Contract No. 2435

**Replacement of Victoria Ave East Bridges over Pilot Butte Creek
and Victoria Ave Widening**

ADDENDUM # 1

May 13, 2015

VICTORIA AVENUE
STANDARD DETAILS & CROSS SECTION

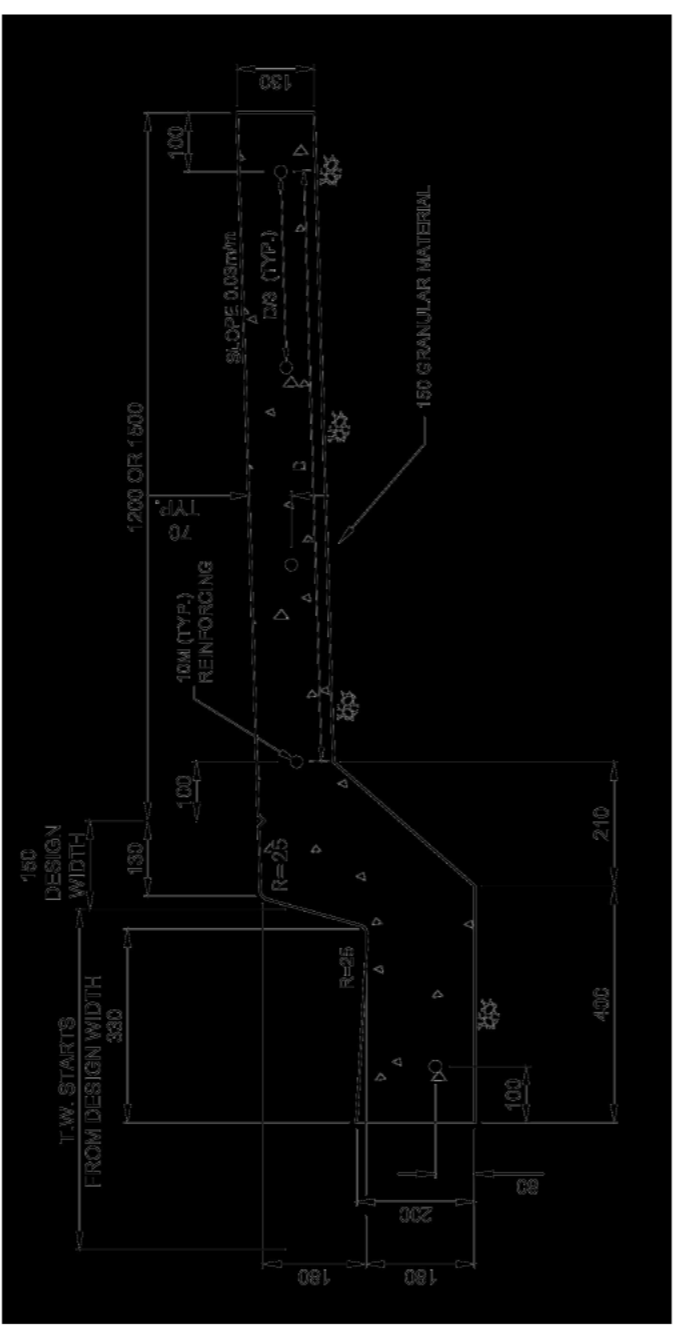
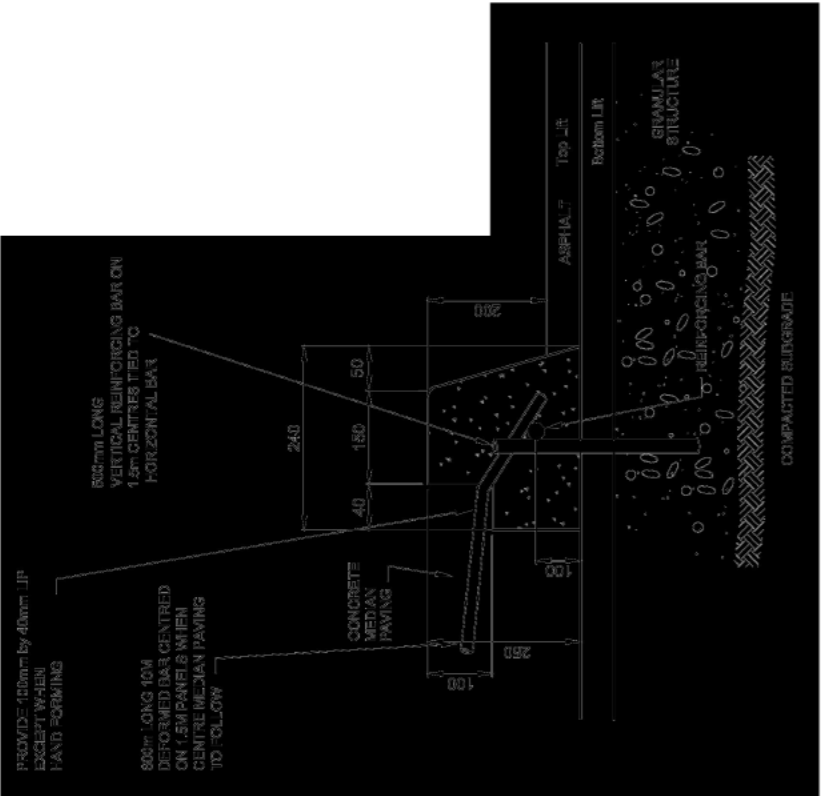
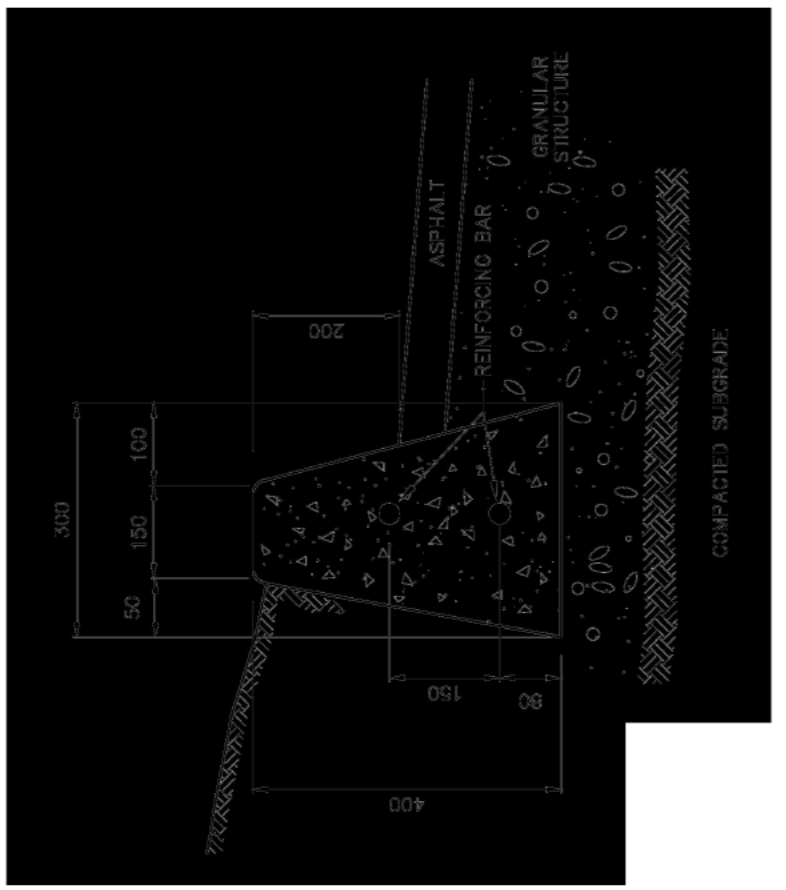
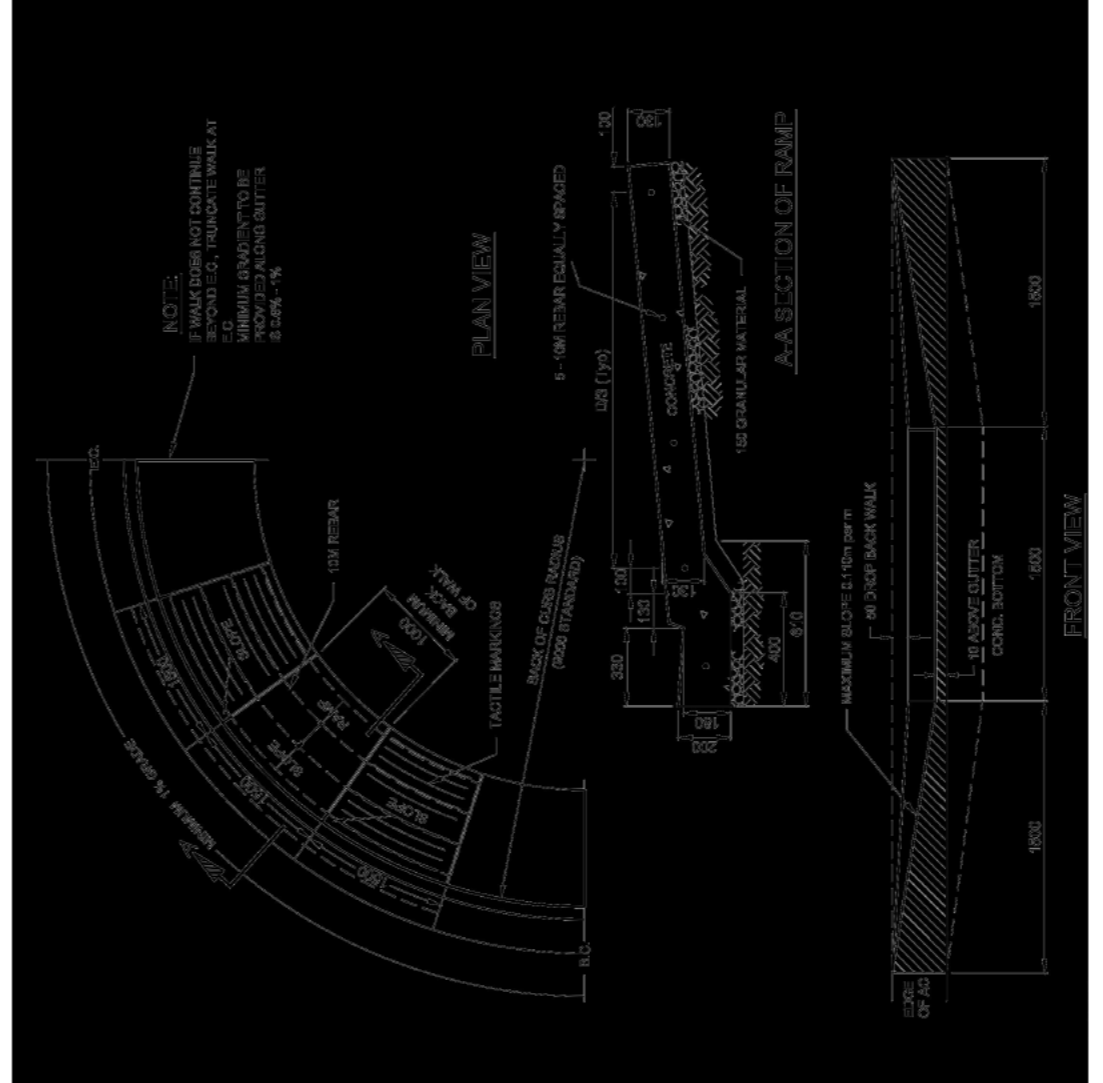
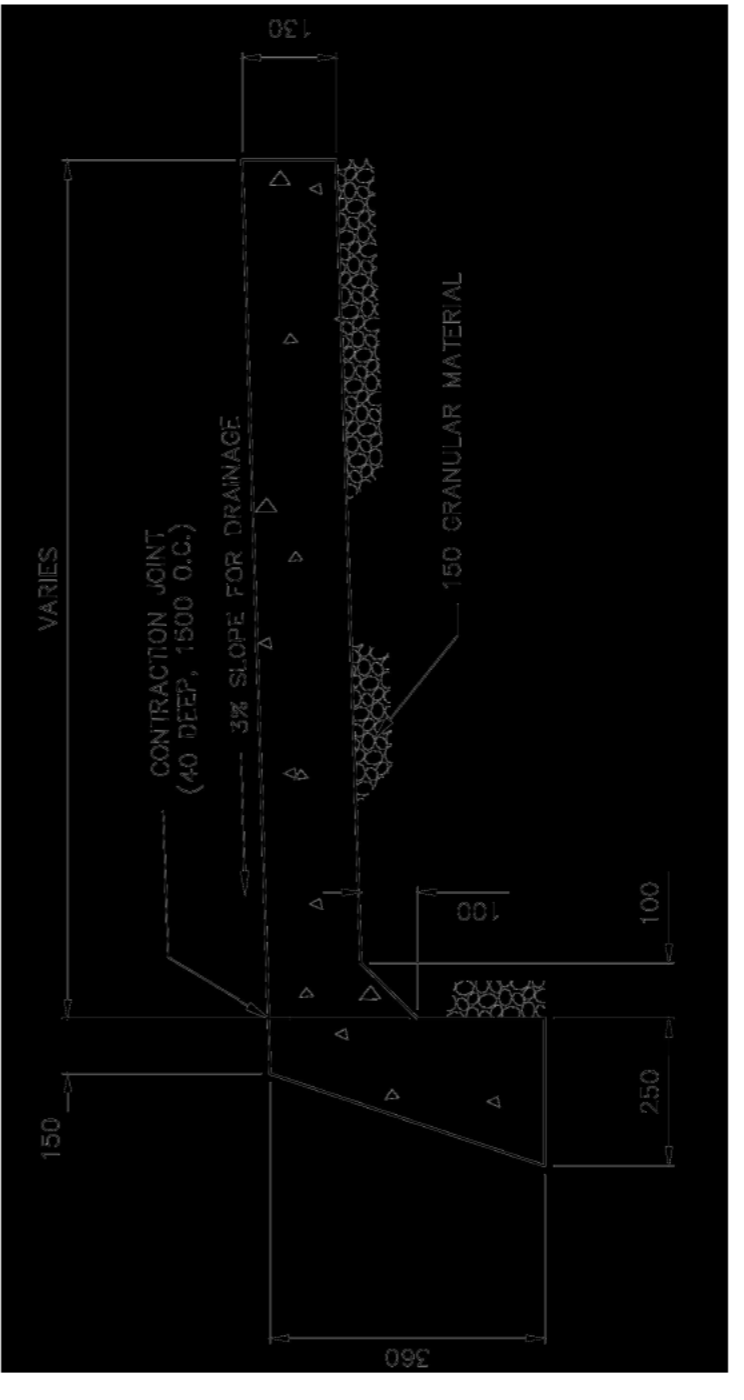
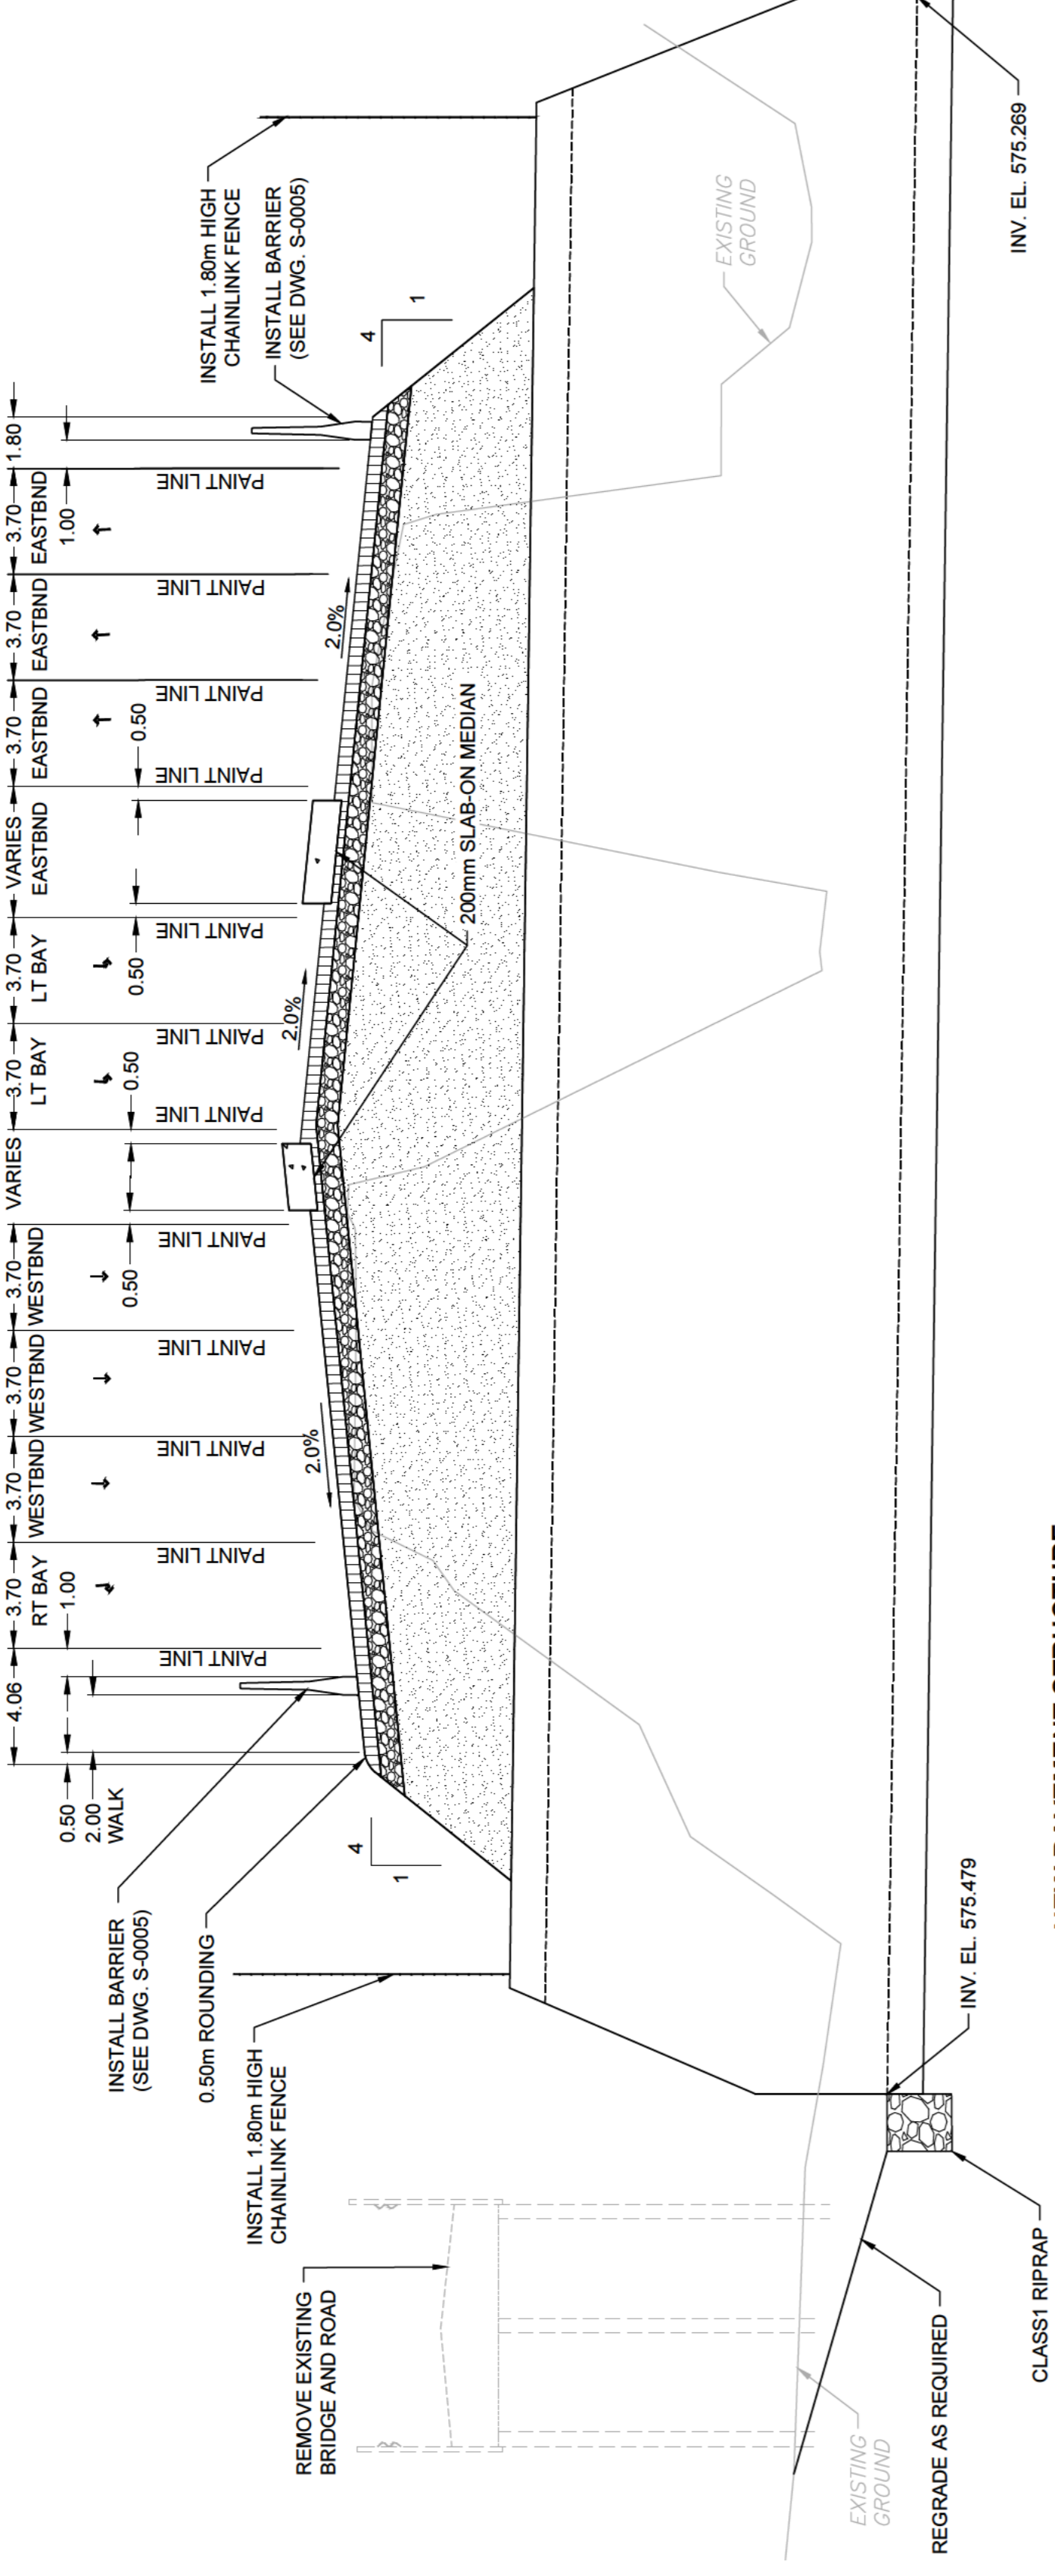
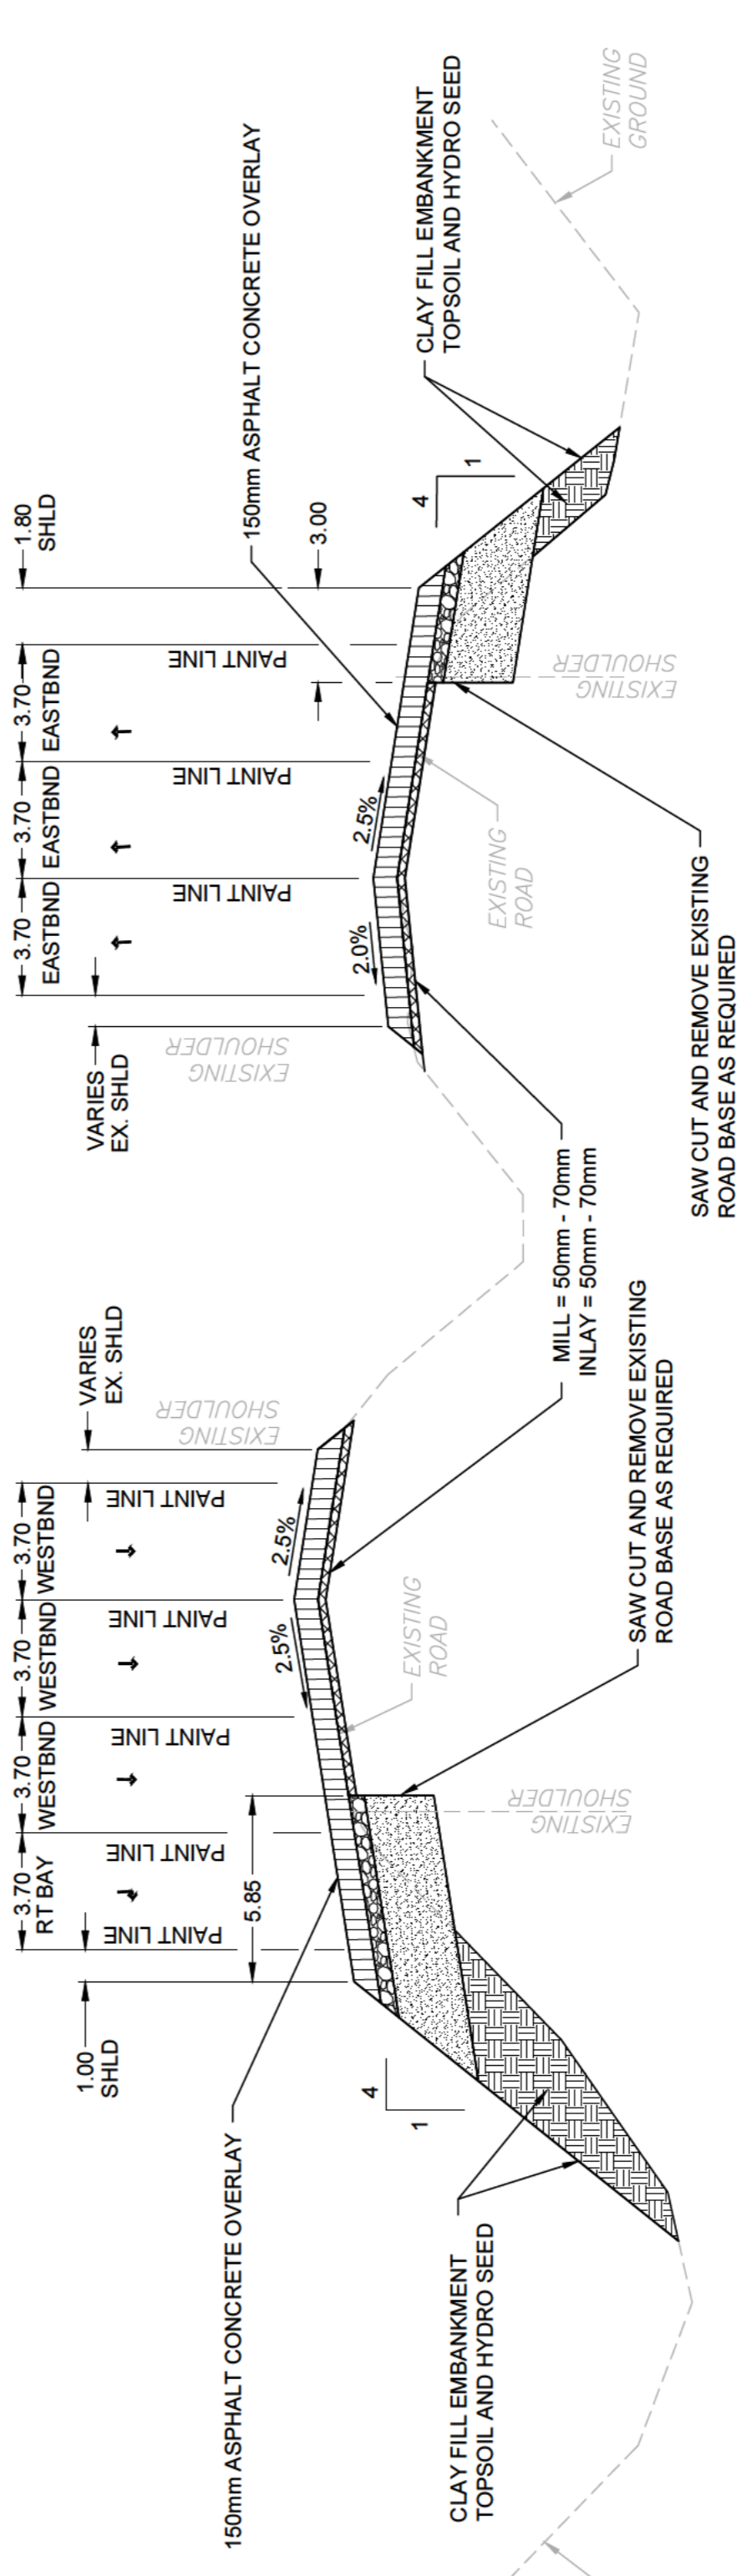
7. DRAWING D-0010 – STANDARD DETAILS & CROSS SECTION

- a) This drawing has been revised and re-issued as Rev. C. Additional details have been added to better clarify the type of curb required, and the fill required for the widening.

- f) There appears to be a discrepancy on two different drawings (legend on drawing D-0005 and section A – A on drawing D-0010) related to the Asphalt pavement structure thicknesses. What is the correct asphalt, Granular Base, Sub Base and Sub -Drainage sand thicknesses over top of the new bridge culvert section?

- i. Rev. C of Drawing D-0010 shows the correct pavement structure on the new culvert.
- g) What are the Asphalt, Granular Base, Sub base and Sub Drainage sand thicknesses to make up the pavement structure on the detour sections?

TYPICAL RETAINING WALL SECTION

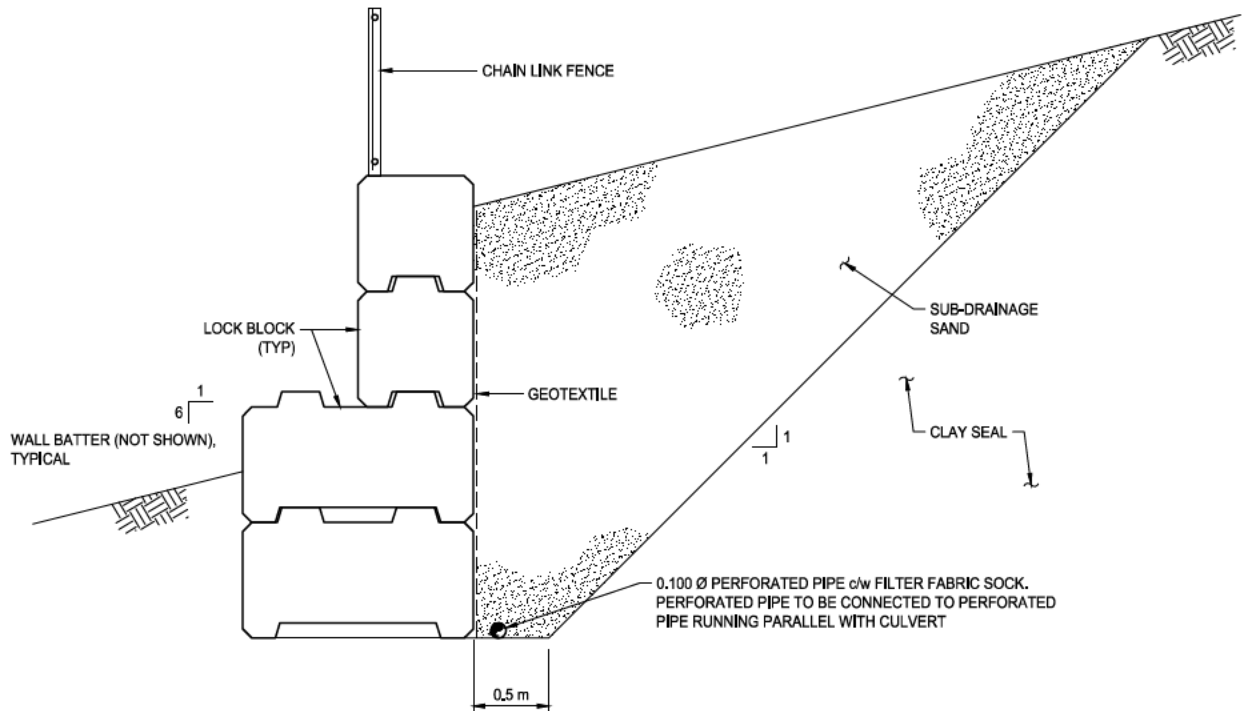
- e) The attached sketch, SK-01, shows the extent of the sub-drainage sand wedge behind the retaining walls, complete with weeping tile. These are the approximate limits of the wall relative to the clay seal behind.

NOTE:
CONTRACTOR TO ENSURE COMPACTION BEHIND BLOCKS DOES NOT
RESULT IN MOVEMENTS OF BLOCKS DURING INSTALLATION
